GUN, TWIN 40 MM, SELF-PROPELLED, M42A1

This amendment forms a part of Military Specification MIL-G-11725B(AT), dated 20 August, 1985, and is approved for use by US Army Tank-Automotive Command, Department of the Army, and is available for use by all Departments and Agencies of the Department of Defense.

FIGURE 1. Profile of test track (artificial bump).

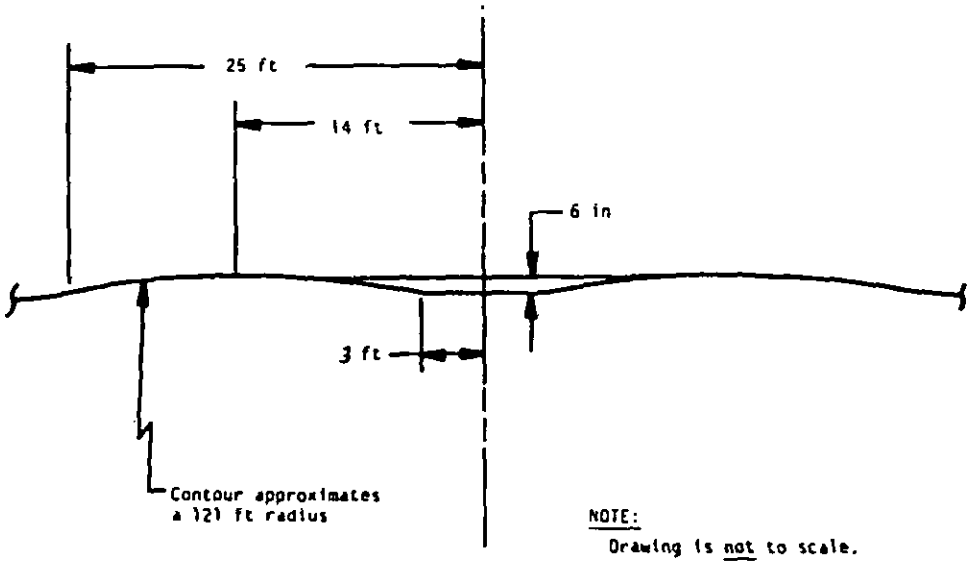
3.4.3 Add the following figure 1:
